Access Compliance Report

Public Rights-of-Way

(Curb Ramps)

| Intersection ID: 29677 | Main Street: CAMERON_CREEK_DR | Cross Street: HUNTINGTON_RIDGE_CT | Location: SE |

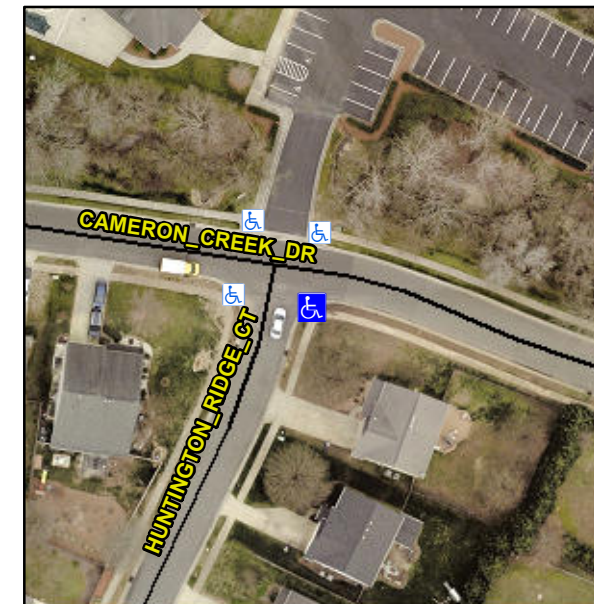
| ADA ID: 2F3763271197 | Ramp Type: BlendTrans1 | Initial Pass/Fail: Fail | Overall Compliance: No |

Not Found, R304.5.1, R304.5.3

| Compliance | Description | Data | Compliance | Description | Data |
|------------|-----------------------|------|------------|-----------------------------|------|
| No | Ramp Width (in) | 45.5 | No | BlendTrans XSlope (%) | 7.0 |

Remove & Replace Curb Ramp With Two New Directional Ramps or Equivalent.
